## EQUUS BEDS GROUNDWATER MANAGEMENT DISTRICT NO. 2

Re: Application No. 45567 – City of Wichita

APPLICATION REVIEW INFORMATION

**Figure 2. – Application No. 45567 Site Map - NW 25-23S-3W**  
 Prepared by: Equus Beds Groundwater Management District No. 2 - 06/30/04

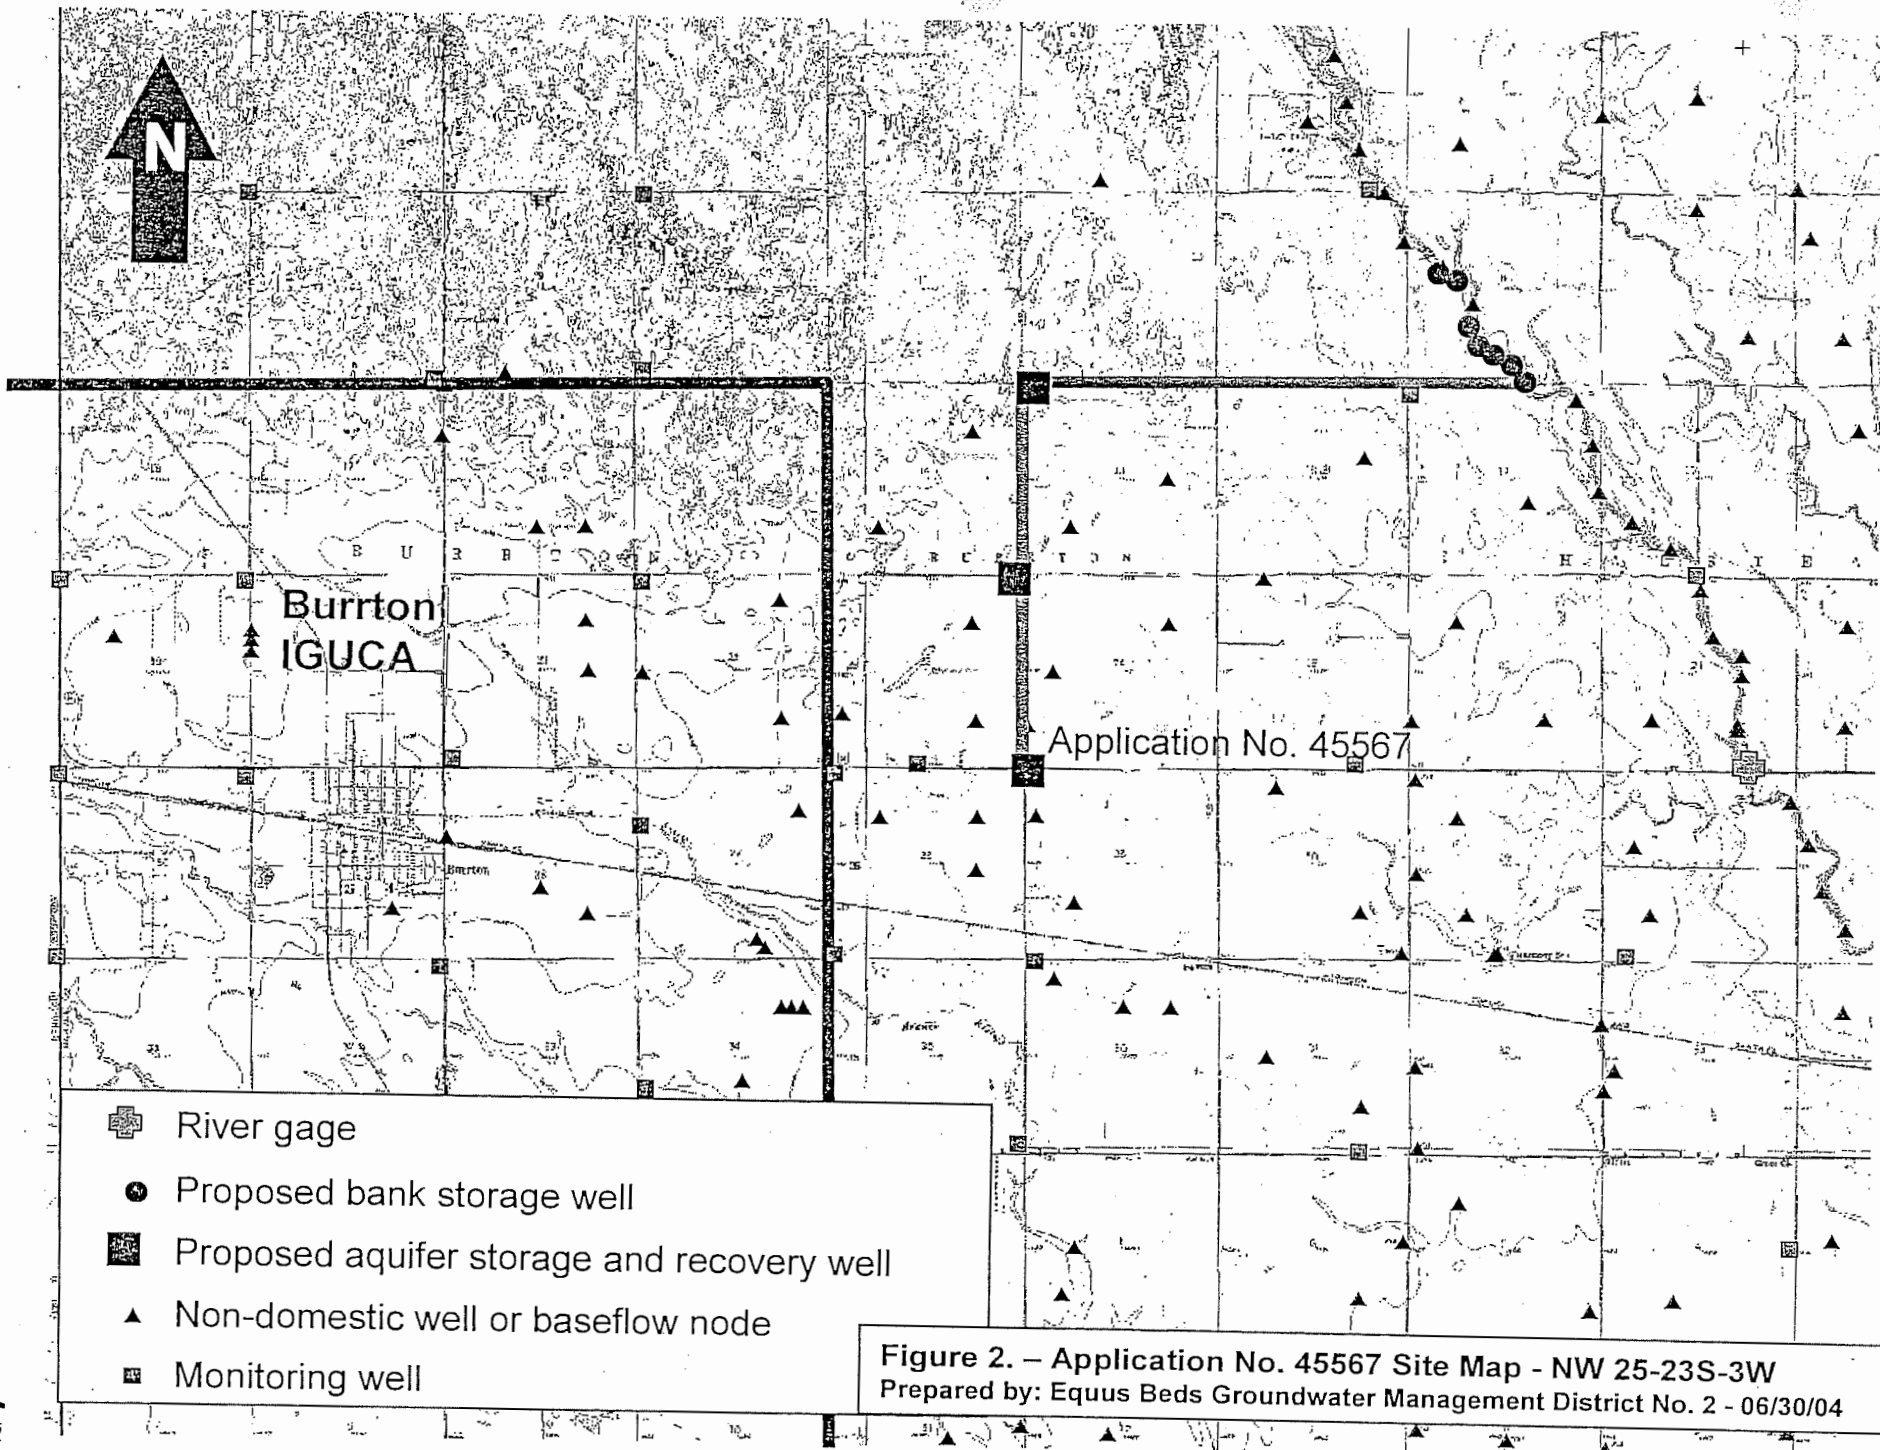
proposed aquifer storage and recovery well located in the Northwest quarter of the Northwest quarter of the Northwest quarter of Section 25, Township 23 South, Range 3 West, Harvey County. The proposed well location is more specifically described as being 5,124 feet north and 5,272 feet west of the southeast corner of said section (figures 1 and 2).

The application does not comply with Well Spacing Regulation K.A.R. 5-22-2. The proposed well is located 1,200 feet north-northwest from an existing irrigation well authorized by water permit no. 37898 (figure 4). The minimum required spacing distance to nondomestic water wells is 1,320 feet.

- 1) the City will provide GMD2 the actual distance from the proposed point of diversion to the nearest nondomestic water wells, substantiating that the proposed point of diversion complies with Well Spacing Regulation K.A.R. 5-22-2. The distances shall be either surveyed by a state-licensed surveyor or engineer, or scaled from an aerial photograph by qualified Harvey County Farm Service Agency staff;

Figure 3. – Basin Storage Area Map - Application No. 45567 Site Map - NW 25-23S-3W

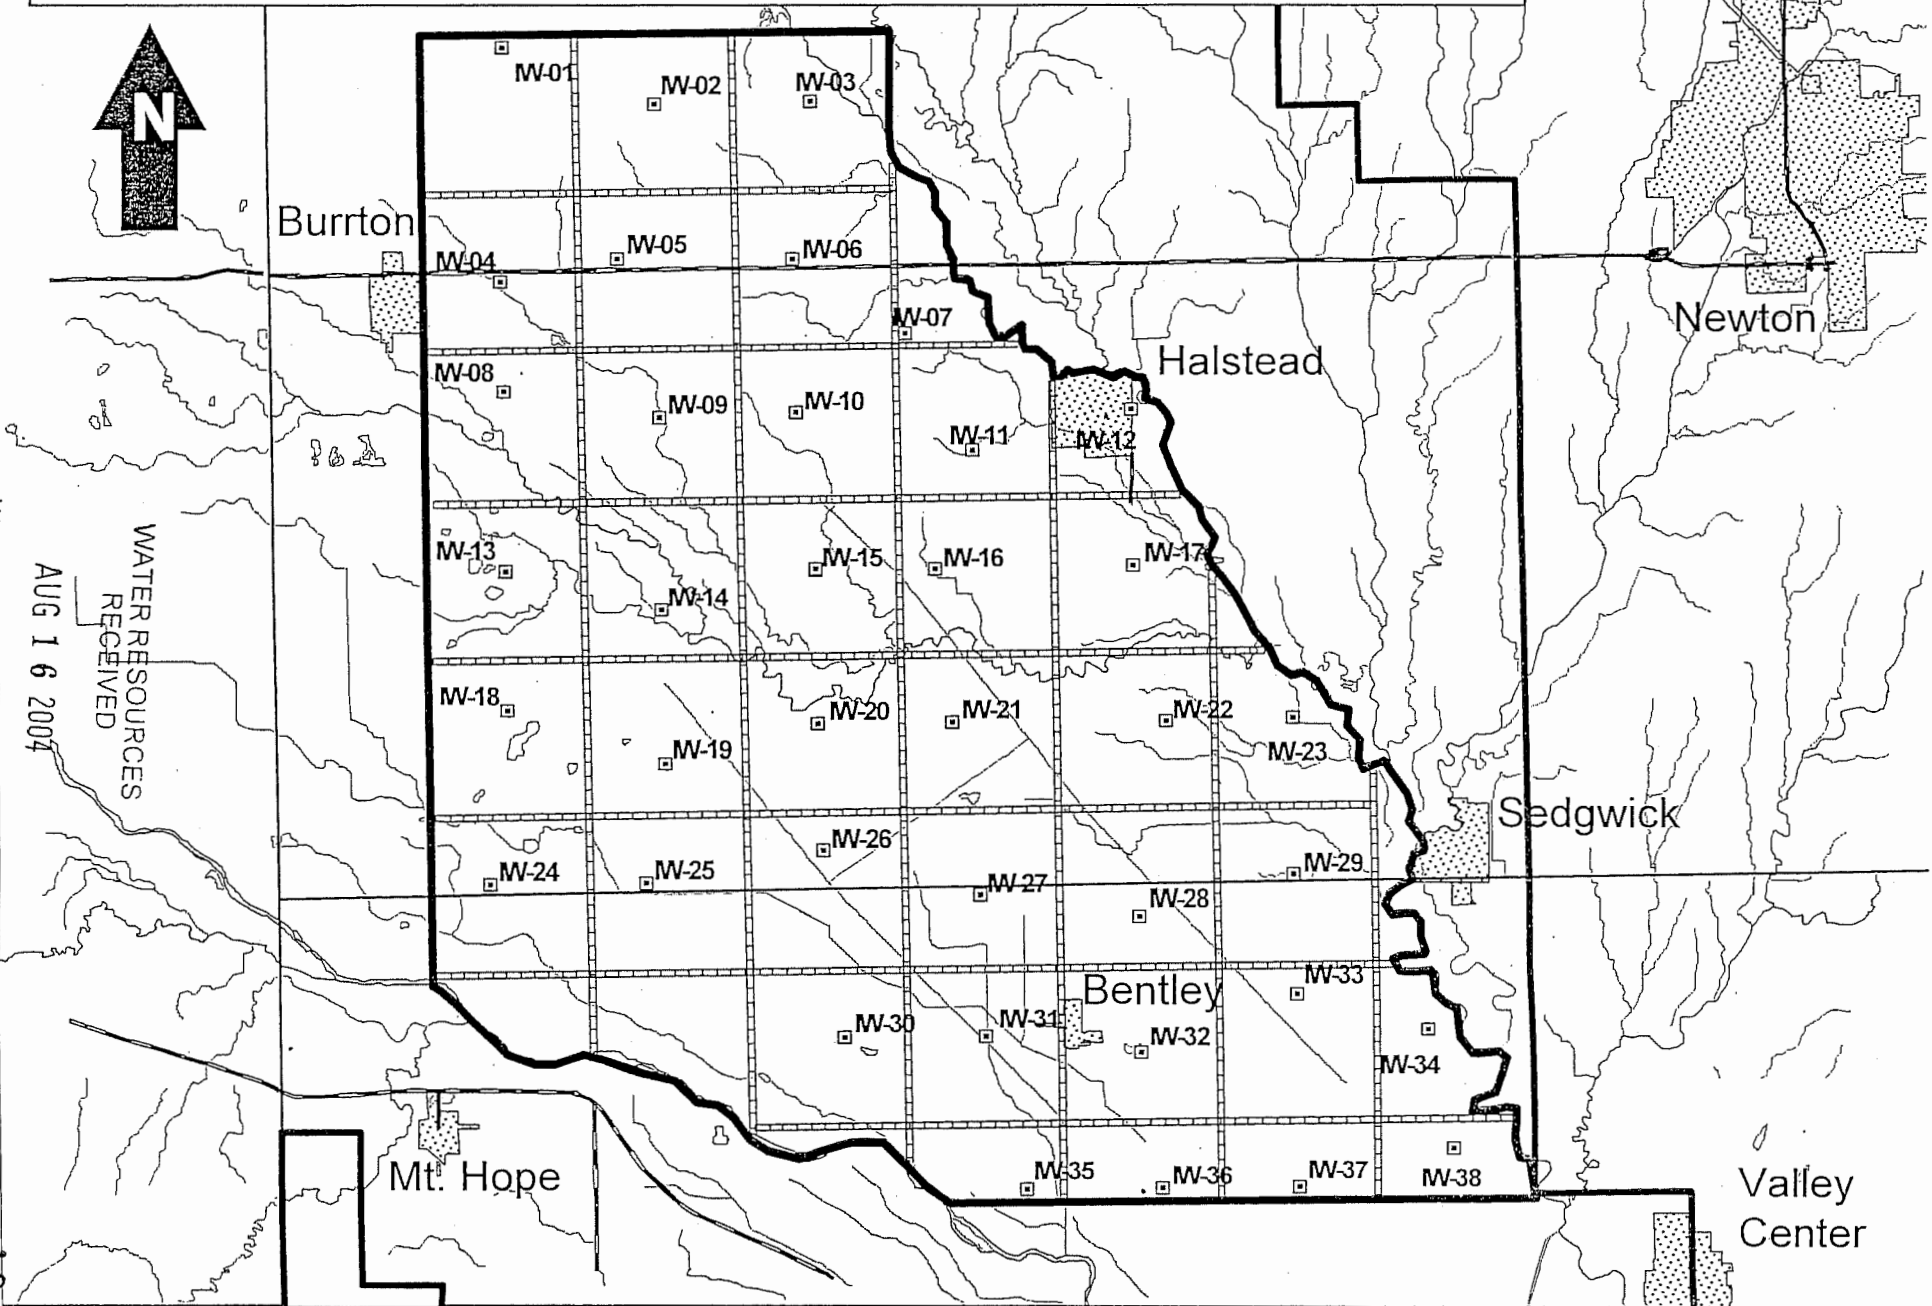
The applicant's proposal for aquifer storage will consist of a basin storage area underlying an area approximately 92,720 acres in size (figure 3). The following Division of Water Resources regulations as defined by K.A.R. 5-1-1, shall apply to the ASR project:

Based on Kansas Geological Survey methodology for optimum monitoring well network design, the basin storage area was sub-divided into of 38 water budget accounting units, each comprised of a four square mile area (figure 3). Each unit consists of a monitoring well site utilized to obtain index water levels, and water quality data.

- 5) as determined by Kansas Geological Survey methodology the basin storage area is divided into 38 water budget accounting units and each unit is assigned an index identification number as shown on figure 3;

Figure 5. – Basin Storage Area Accounting Unit Map- Application No. 45567 Site Map - NW 25-23S-3W  
 Prepared by: Equus Beds Groundwater Management District No. 2 - 06/30/04

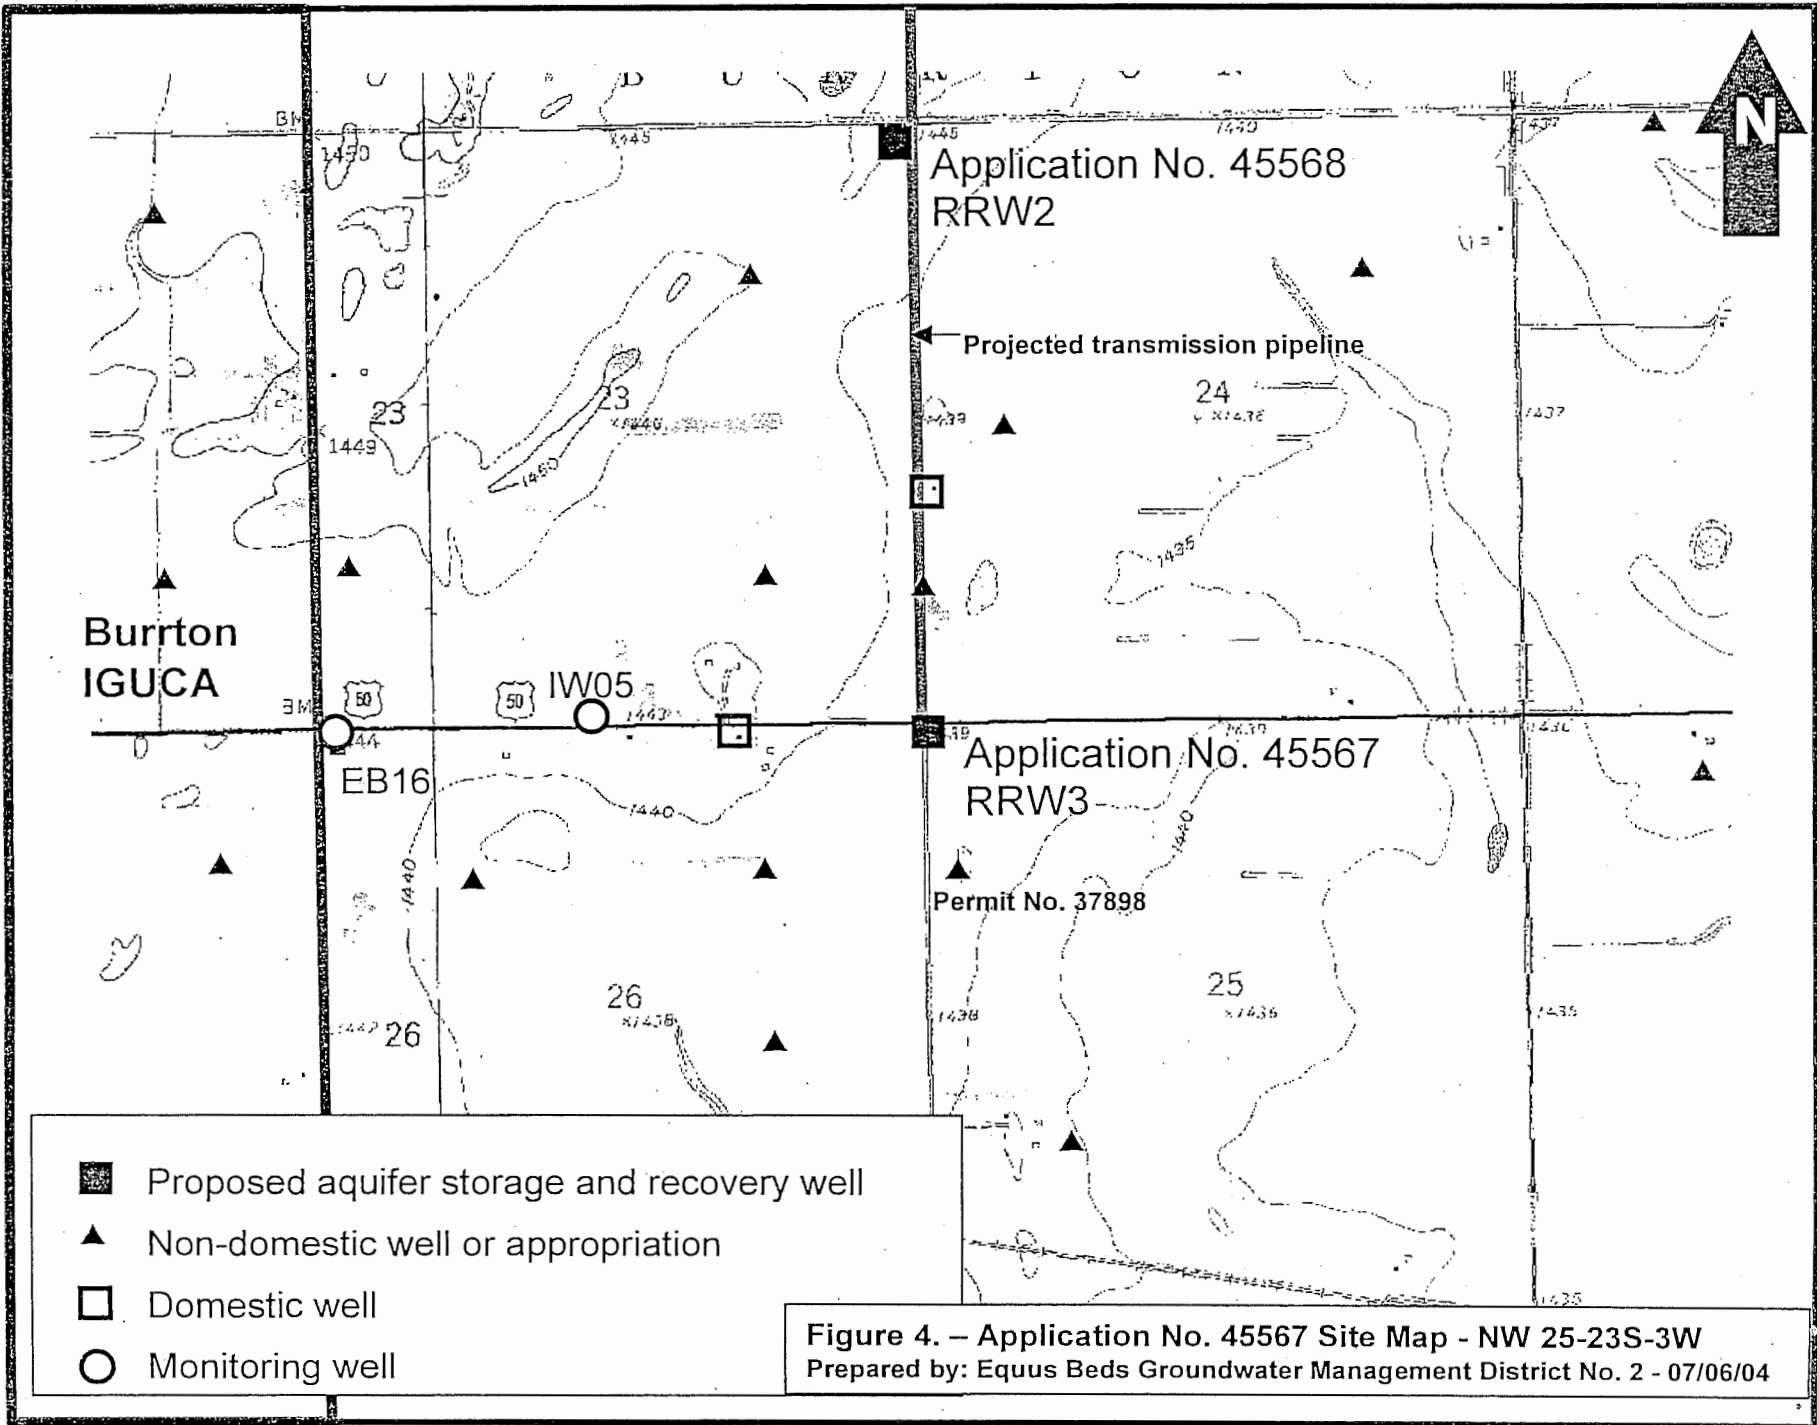
The proposed ASR well is located in the NW-NW-NW of Section 25, Township 23 South, Range 3 West (figure 4), and at a point near the center of basin storage unit no. 5 (figure 5).

**Figure 6. – Application No. 45567 Site Map - NW 25-23S-3W**  
 Prepared by: Equus Beds Groundwater Management District No. 2 - 06/30/04

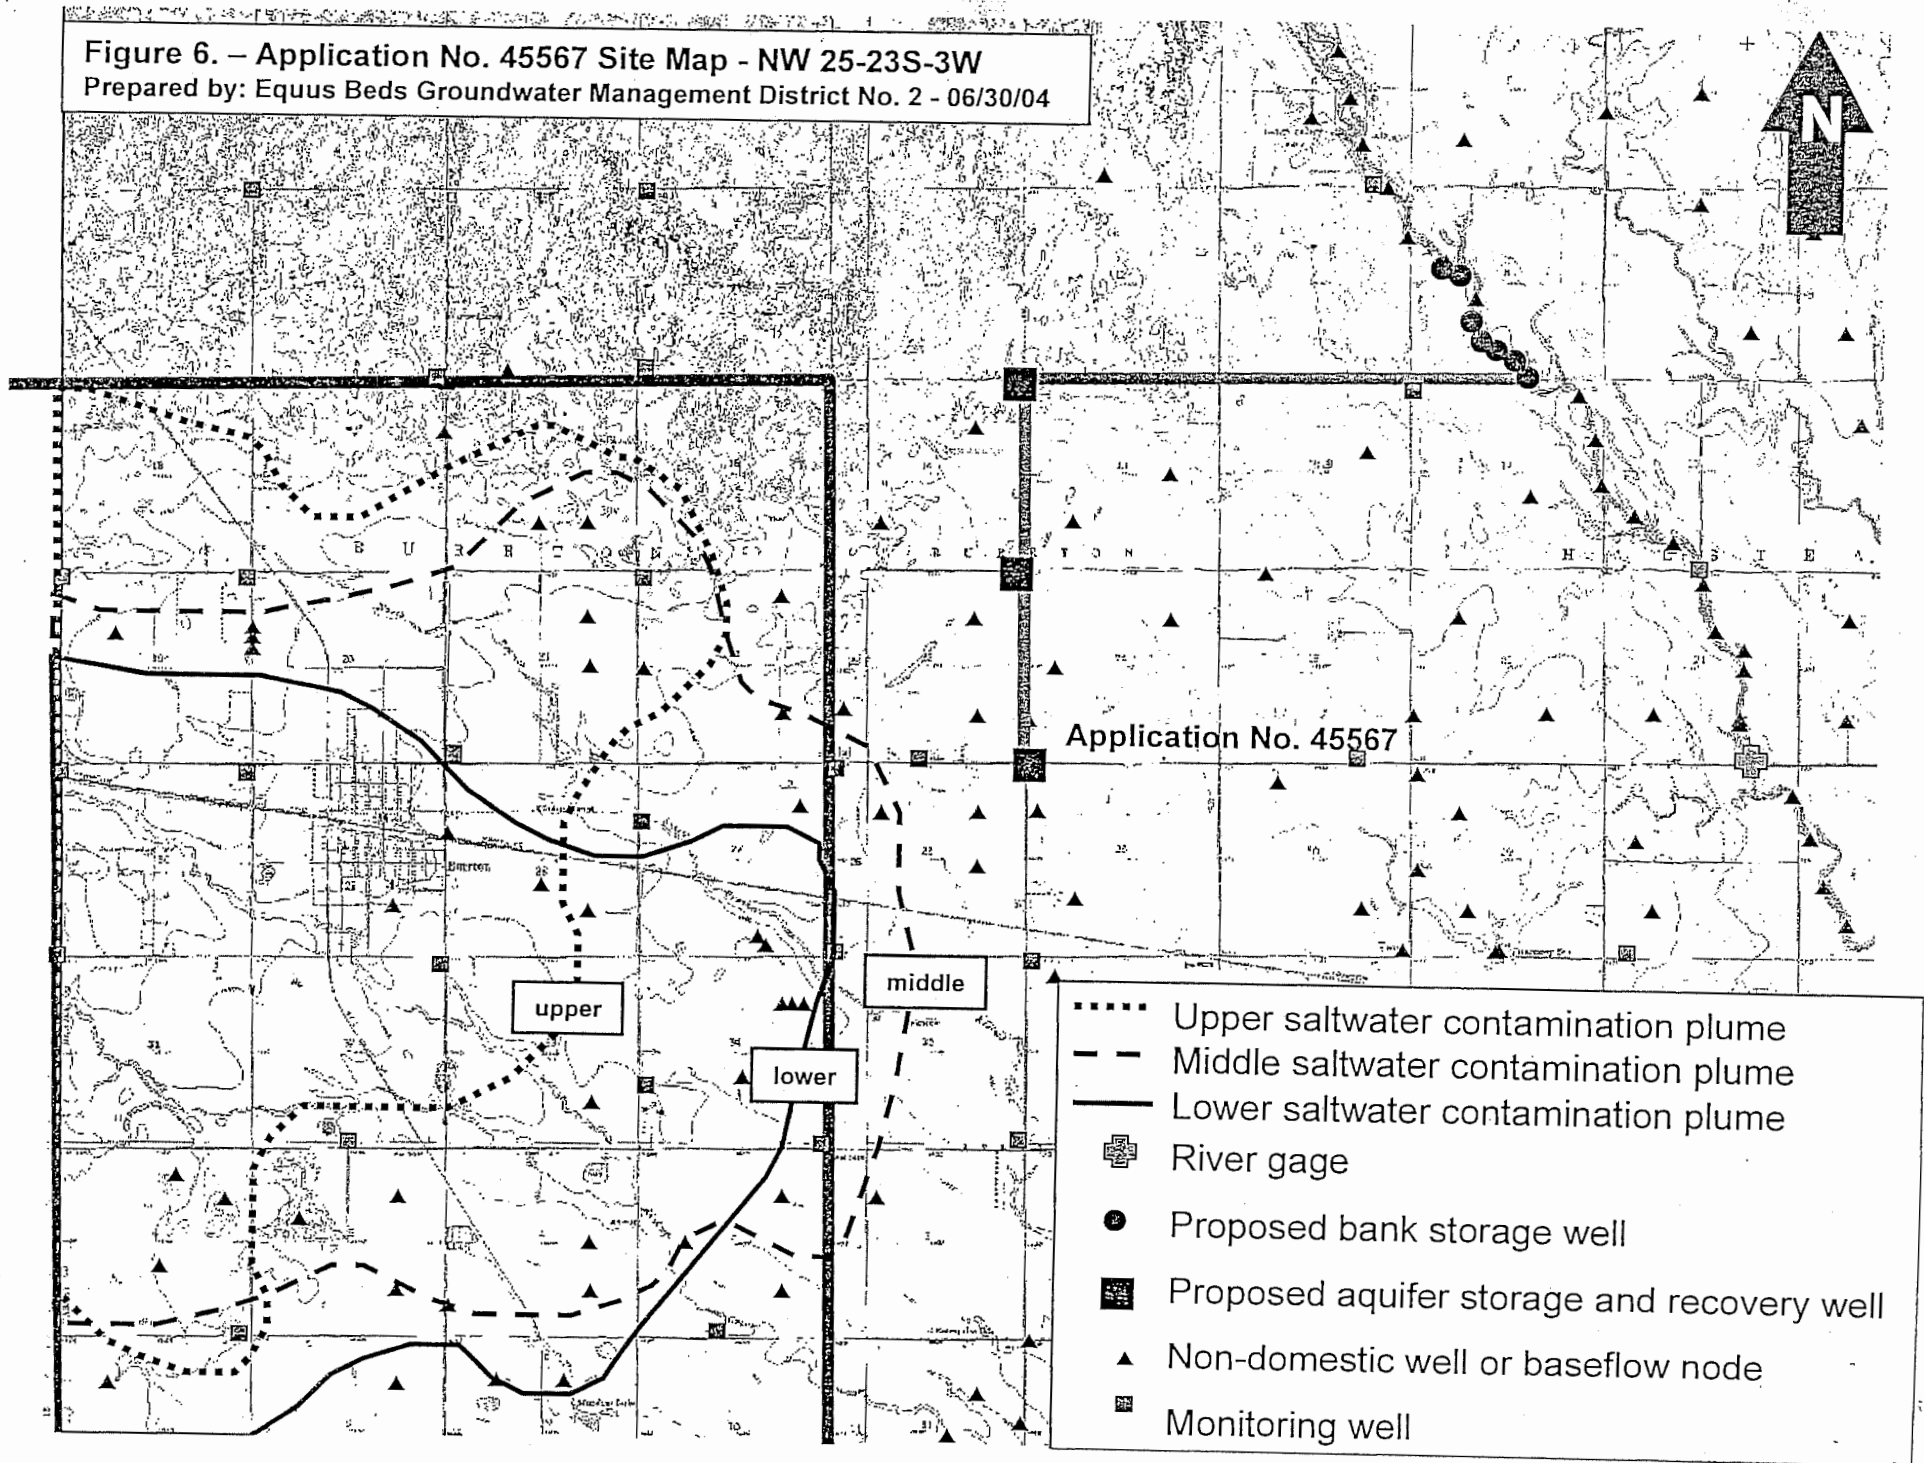
The proposed ASR well is located one mile east of the Burrton Intensive Groundwater Use Control Area Boundary (figure 6). Saltwater contamination plumes with chloride concentrations greater than 250 mg/L, are located west of the proposed well site (figure 6). The nearest saltwater plume is in the middle portion of the aquifer (depth 125 feet bls) located approximately one-mile west of the application and moving to the southeast.
